GREEN INFRASTRUCTURE

23178
Proposed Development
at Lucan

July 2023

SUDDS STRATEGY

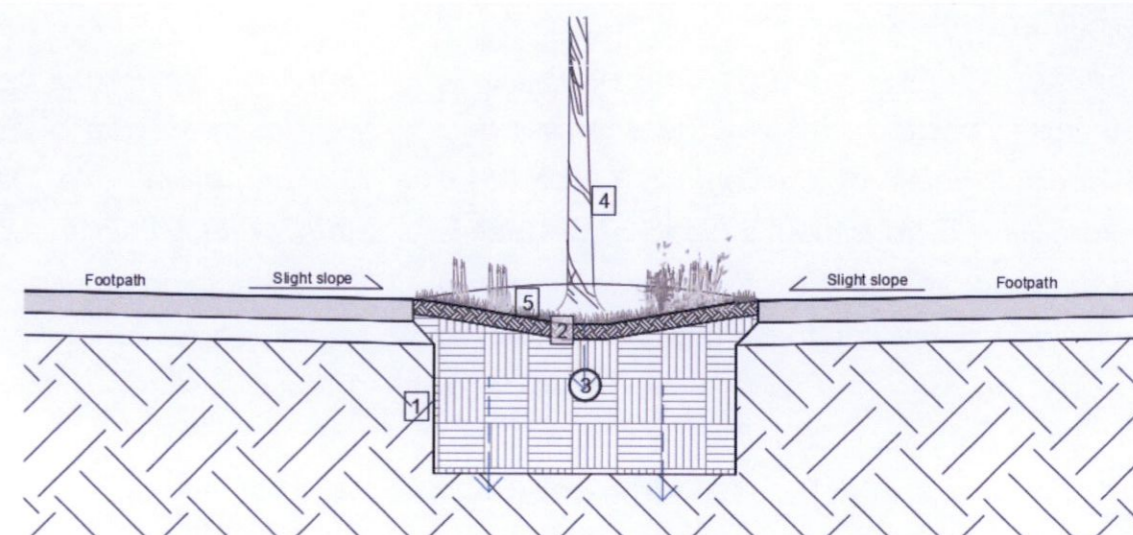
The Applicant is requested to provide the following clarification in relation to the proposed drainage and water services infrastructure:

(i) Submit a report showing site specific run-off rate and run-off volume calculations to clarify what water storage capacity is required to be attenuated to match the pre-developed greenfield run off rates on site.

(ii) Submit a report clearly showing the required and the provided volume of storm water attenuation, namely how surface water up to and including the 1:100 (1%) year critical storm with climate change allowance (20%) will be attenuated on site.

Should there be a requirement to provide additional surface water attenuation, the above ground attenuation (such as SuDS) is preferred opposed to underground attenuation. In this case submit a report and drawings in plan and cross-sectional view with the inclusion of additional SuDS for the proposed development such as but not limited to the following:

(iii) Submit details of the rainwater storage capacity in m³ for all proposed SuDS. Prior to the providing the above outlined information, the Applicant is advised to liaise directly with the Drainage and Water Services Department of South Dublin County

(ii) The revised landscape plan incorporates a strategic integration of various Sustainable Drainage Systems (SuDS) features, designed to efficiently manage stormwater within the proposed development. These carefully selected elements align with principles of sustainability, ecological enhancement, and effective stormwater management.

At the forefront of our SuDS strategy is the allocation of a bioretention area located at the entrance corner of the development. This area functions as a natural filtration system, enabling stormwater to naturally seep into the ground. This not only helps attenuate stormwater but also significantly enhances the ecological quality of the site. The bioretention area naturally purifies stormwater as it infiltrates the soil, promoting the overall health and vitality of the local ecosystem.

In addition to the bio-retention area, our proposal introduces a series of rain gardens strategically positioned along the driveway. These rain gardens are accompanied by thoughtfully placed tree pits, creating a harmonious blend of aesthetics and functionality. By effectively collecting and managing stormwater, these features contribute to reducing surface water runoff. Natural infiltration processes are facilitated as stormwater gradually soaks into the soil. This approach aligns with our commitment to sustainable stormwater management and enhances the overall environmental performance of the development.

Furthermore, we have incorporated permeable paving in both the front and back gardens. This choice of paving material significantly improves stormwater management by allowing water to permeate through the surface and into the ground. This permeability reduces the risk of excessive runoff and helps maintain a healthier balance between the development and the surrounding environment.

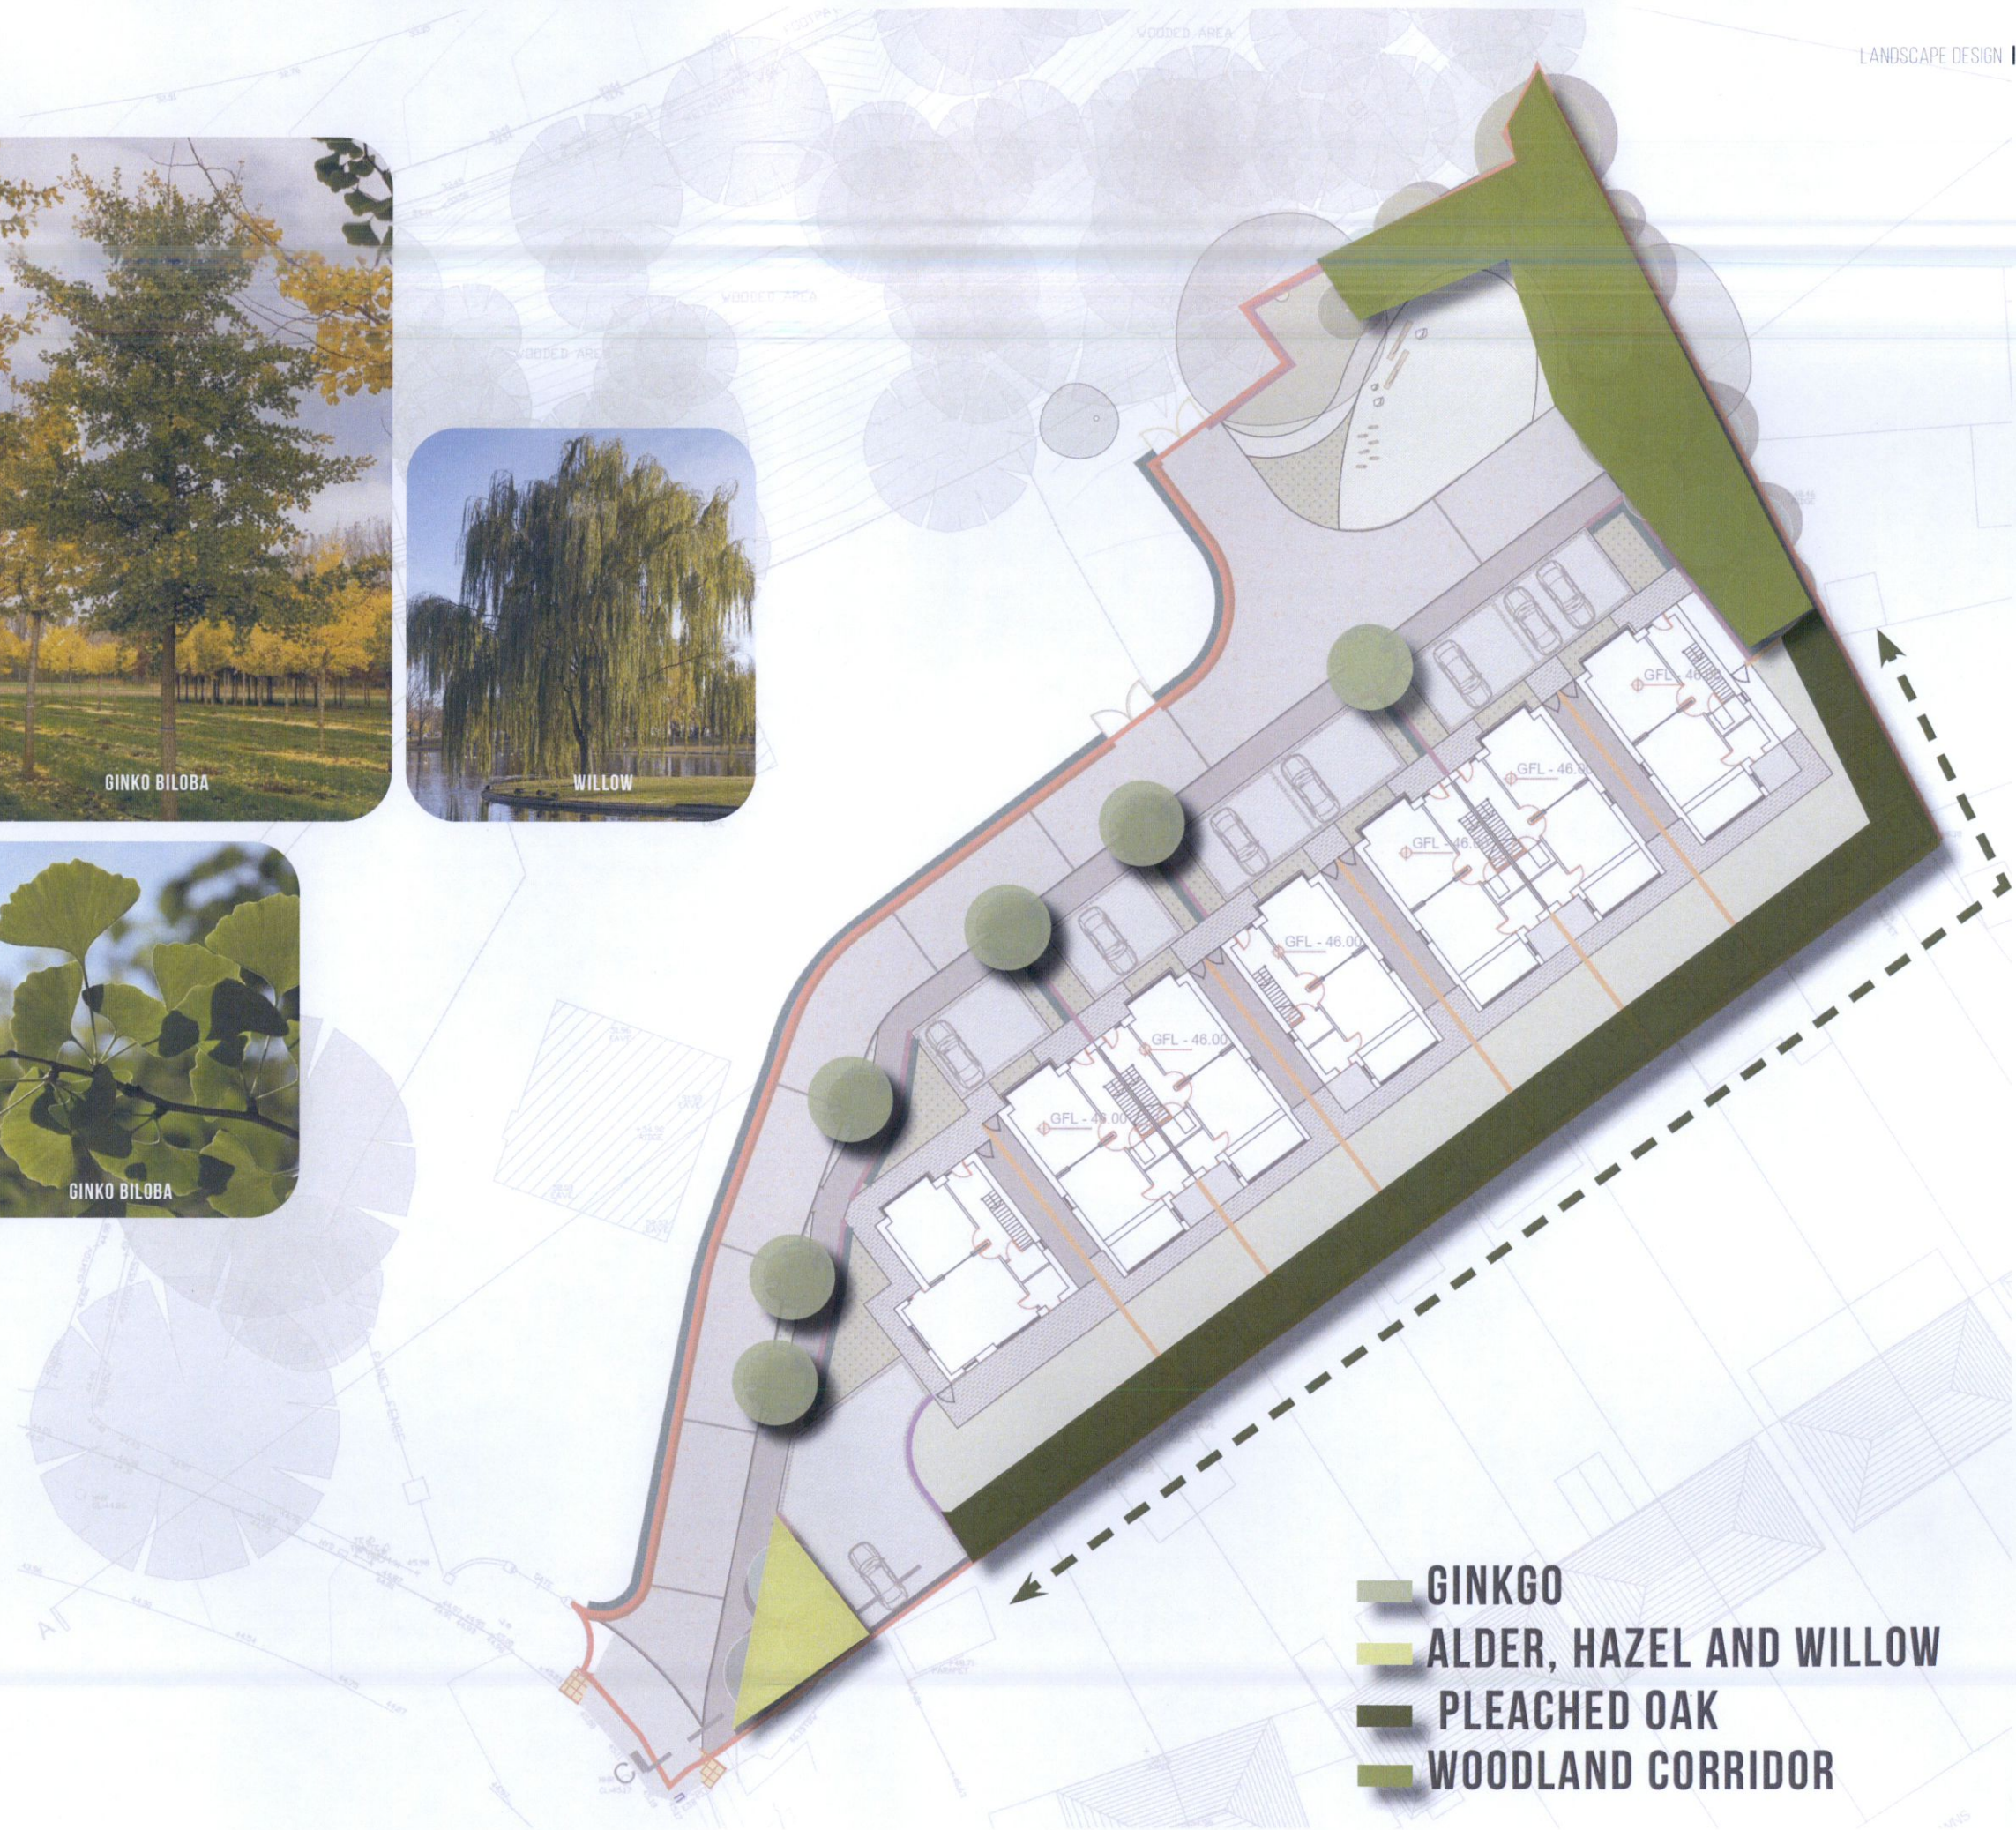
The applicant has not provided any street trees that are up to South Dublin County Council's standards. Street Trees proposed are not classified as such if they are located in driveways. Miyawaki planting is also not considered to be street trees. The planting that has been proposed is unacceptable. The Miyawaki planting proposed differs greatly from what is widely understood to be Miyawaki planting. In this regard, the Applicant is requested to provide a more appropriate Planting Plan to include street trees and appropriate species of planting. Prior to providing a revised Planting Plan, the Applicant is advised to liaise directly with the Parks and Public Realm Department of South Dublin County Council.

In response to these concerns, we have made significant adjustments to address the issues raised. The trees, which were initially located within driveways, have been repositioned to align with the road edge along the path. Additionally, the number of trees has been increased from 4 to 6, reflecting our commitment to enhancing the tree canopy within the development.

To further ensure the long-term health and vitality of the newly planted trees, a meticulous approach has been adopted. The trees are now integrated into rain gardens, a design choice that not only contributes to stormwater management but also nurtures optimal growing conditions for the trees. Moreover, a root barrier has been proposed to encircle the trees, safeguarding against any potential root-related issues.

Regarding tree species selection, it's worth highlighting that the Ginkgo biloba tree has been chosen due to its favourable root ball characteristics (r/b, 4x trpt 20-25cm gt.). This selection takes into account the tree's ability to thrive within the proposed rain garden environment while minimising potential disruptions to the surrounding infrastructure.

In an effort to increase the density of tree planting and amplify the ecological benefits, our revised landscape plan introduces a strategic addition: a screening row comprised of pleached Quercus ilex trees (r/b, 3x trpt 14-18cm gt.). The
